Packet Guide

**BAR MINUTES
CITY OF CHARLOTTESVILLE
BOARD OF ARCHITECTURAL REVIEW
Regular Meeting
June 16, 2020 – 5:30 p.m.
Zoom Webinar**

STATE	FEDERAL AID		STATE		SHEET
ROUTE	PROJECT		ROUTE	PROJECT	NO.
VA.	BR-5104 (159)		20	0020-104-101, B602	9

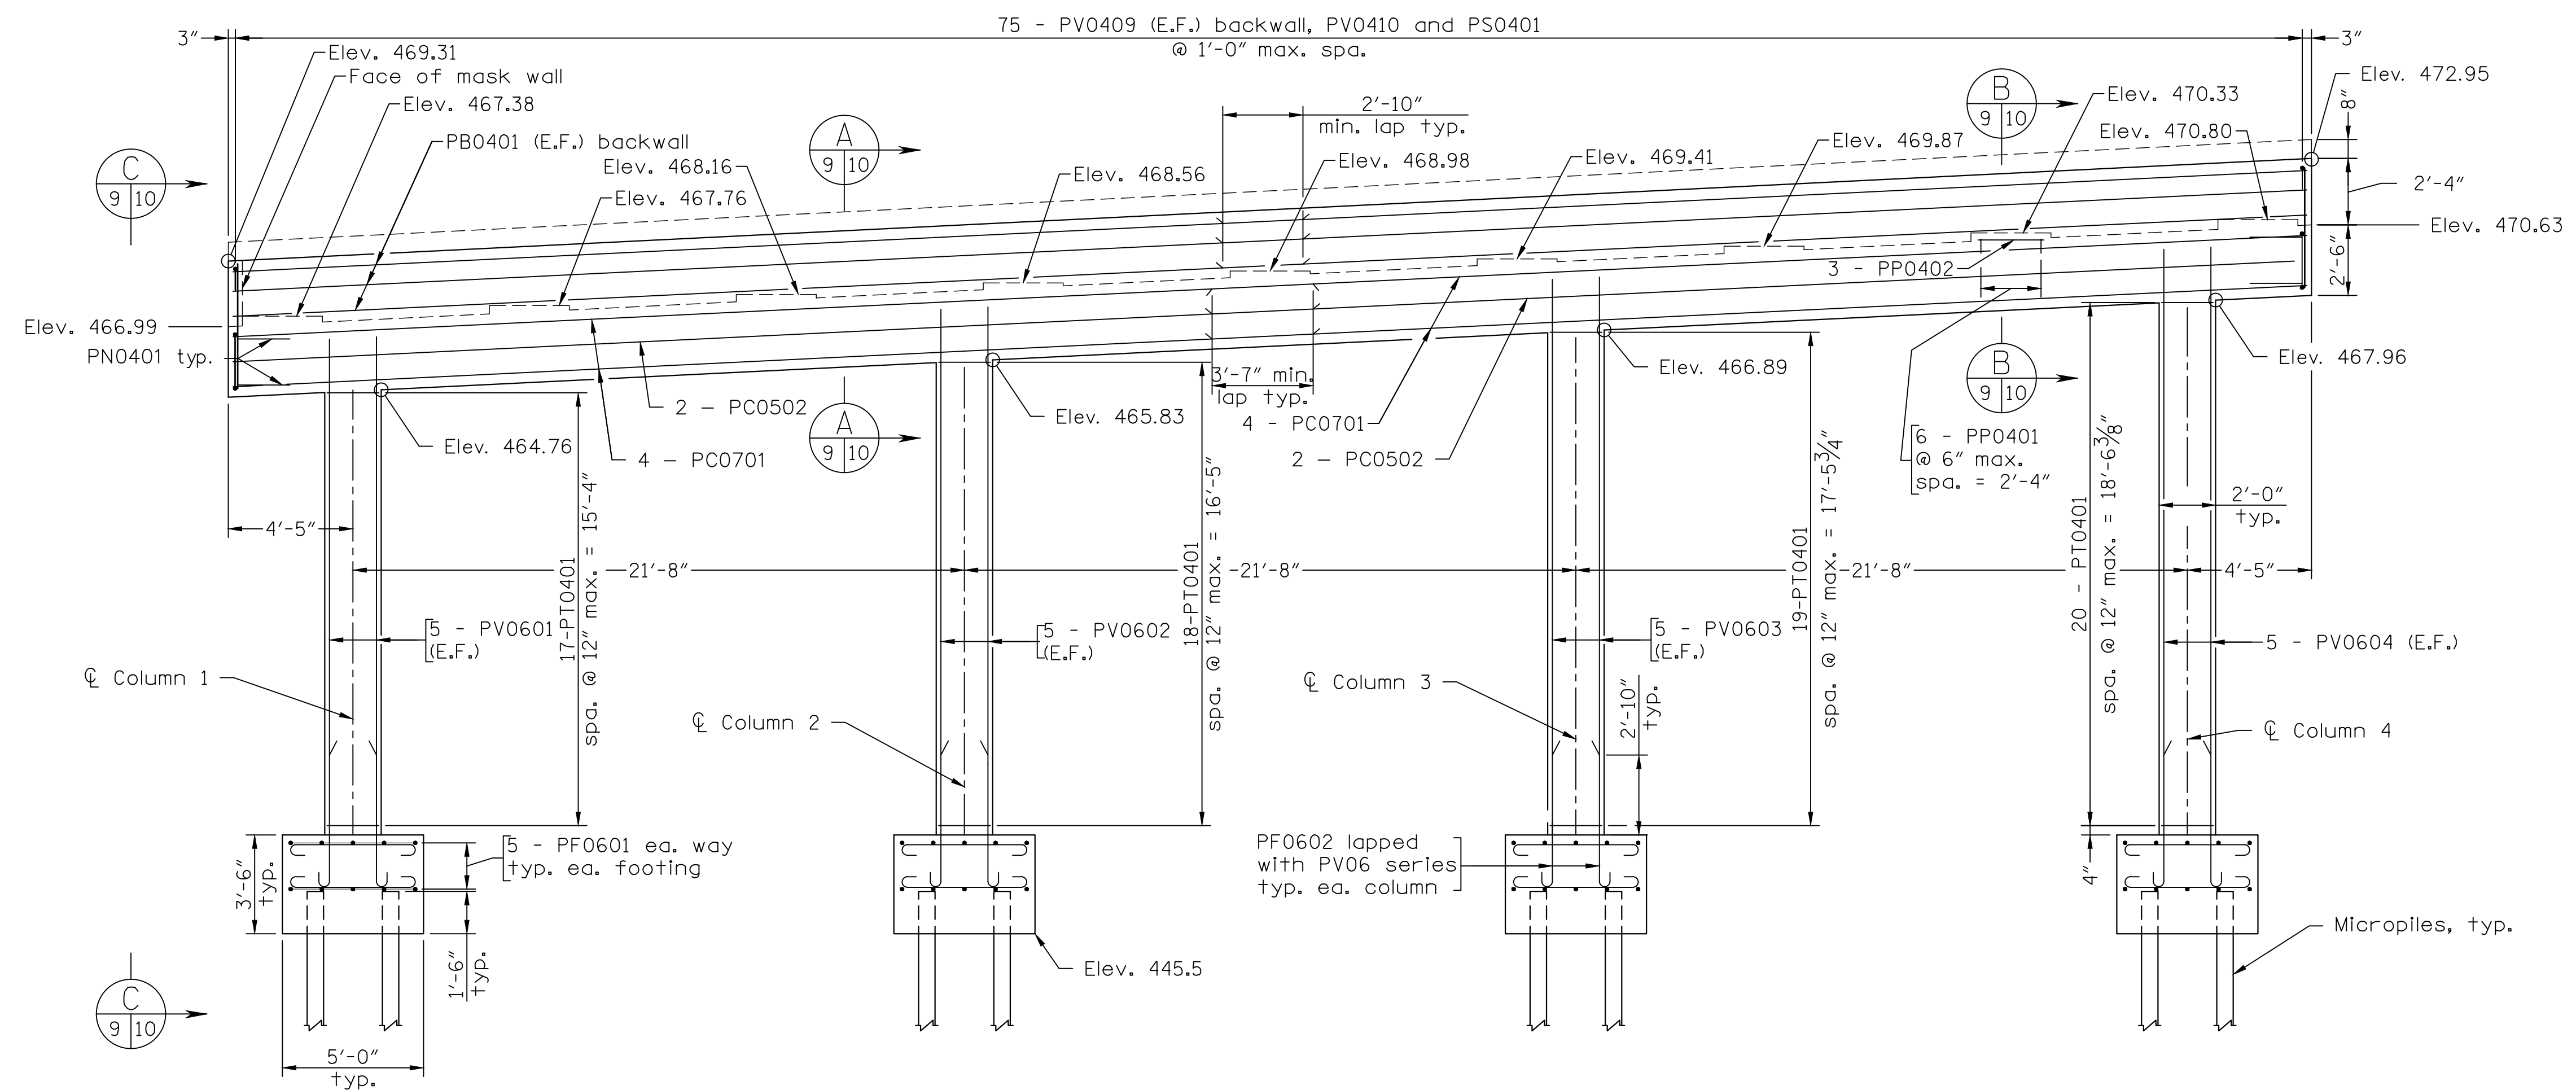
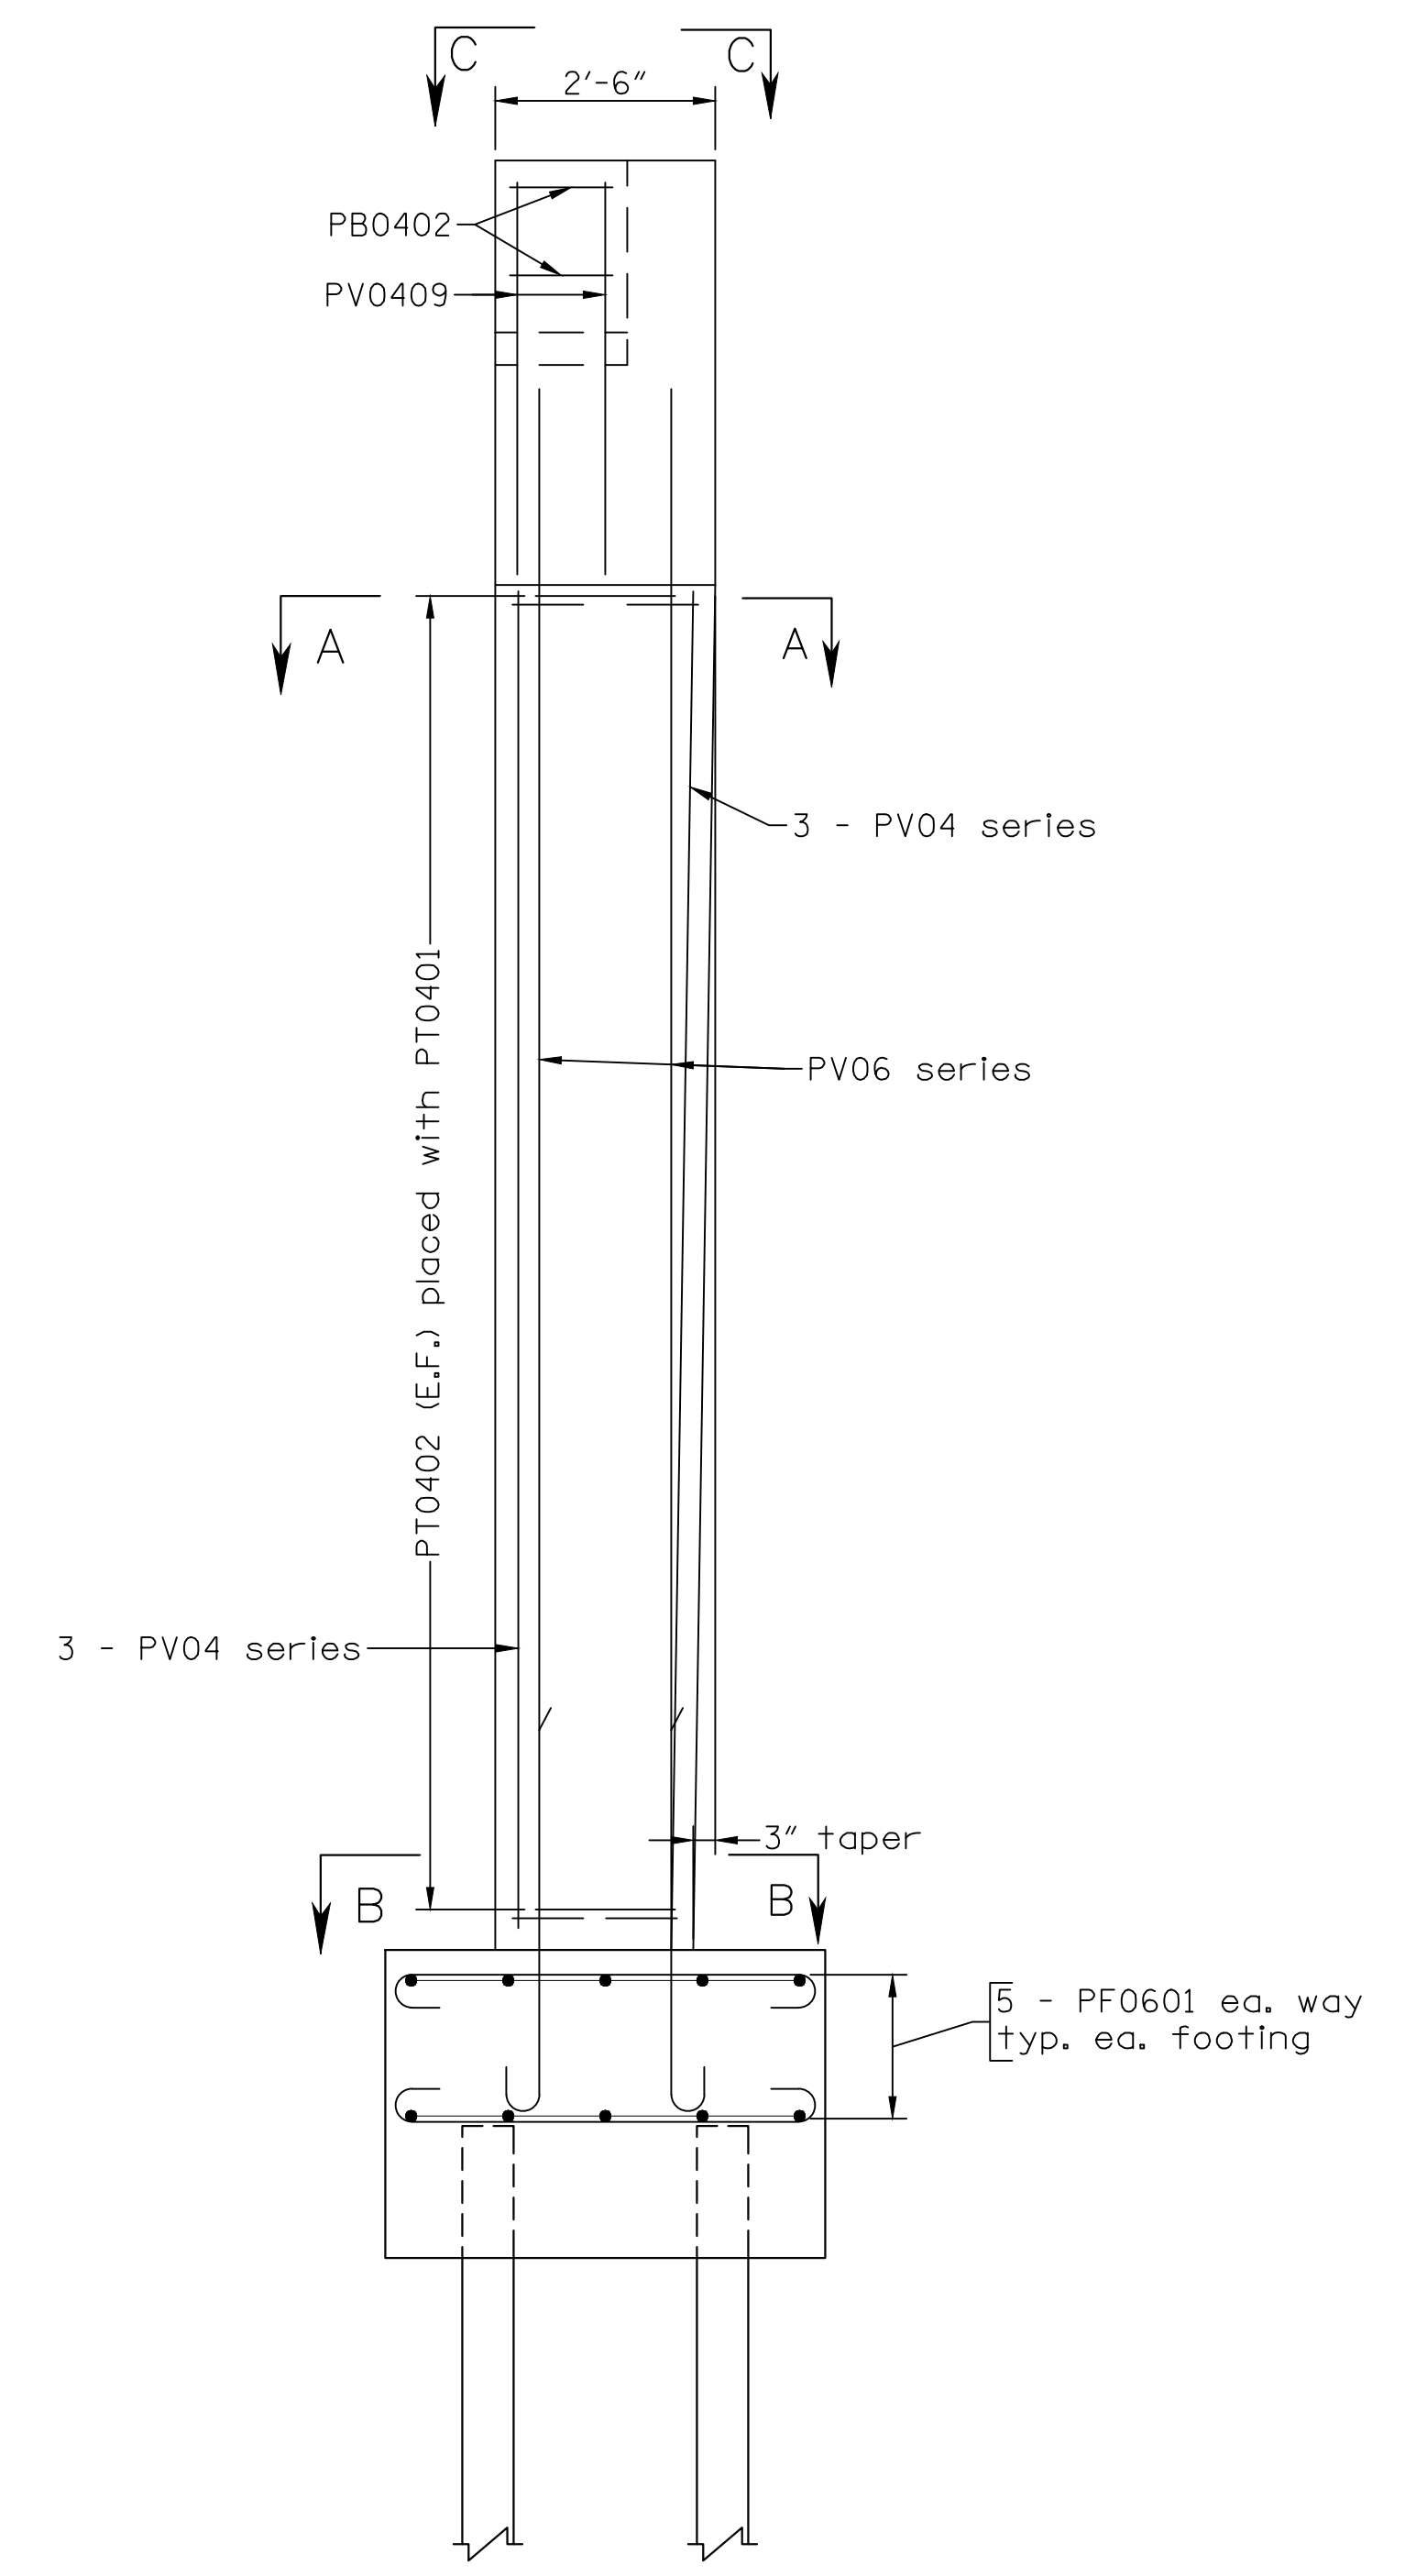
- Added a mask wall at the west end of the pier/overhang to hide the ends of the beam (Sheet 9 – face of mask wall, Sheet 10 – Section C)
- Extended the deck 3" beyond the backwall on the pier/overhang to create a shadow line at the joint between the parapet, deck, and backwall (Sheet 15 – Transverse Section Span a)
- Added a taper to the south face of the columns at the pier (Sheets 9 and 10 – shows 3" tapers of each pier)

REVISED	STATE	ROUTE	STATE PROJECT	SHEET NO.
	VA	20	0020-104-101 C-501	8(4B)

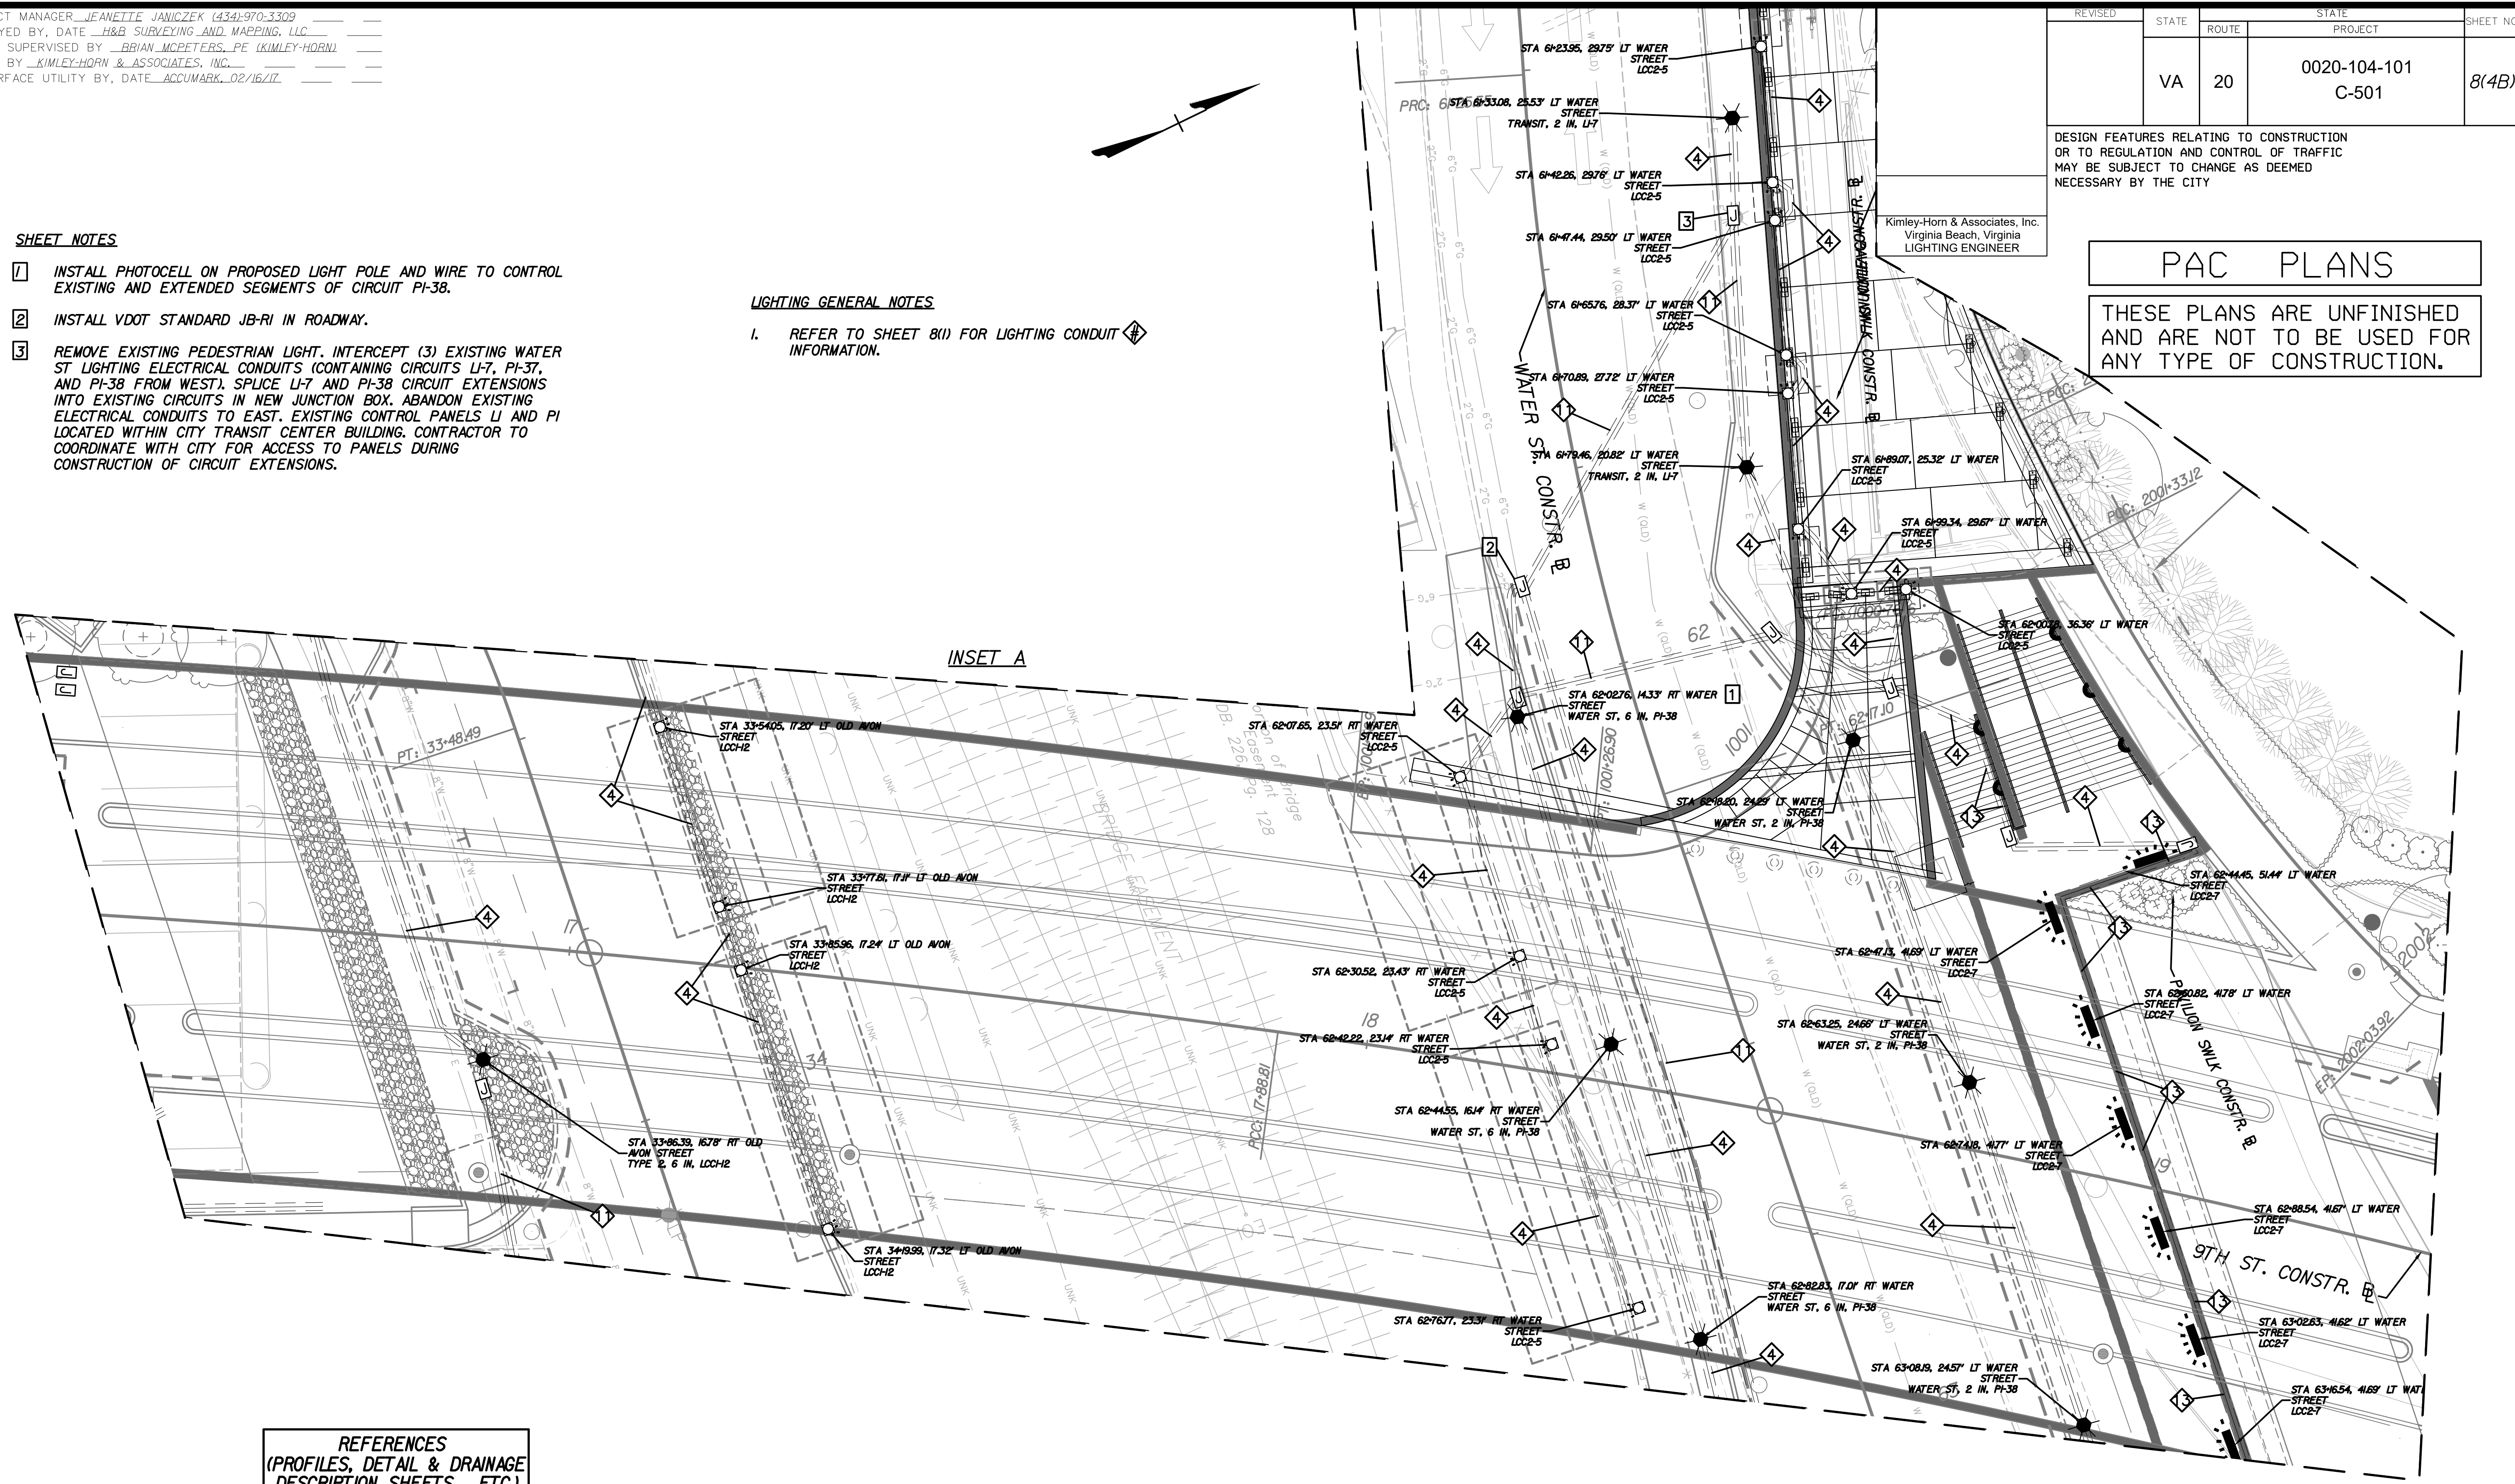
The locations of the previously approved light fixture to highlight the bridge piers have been finalized and are shown on sheet 8(4B).
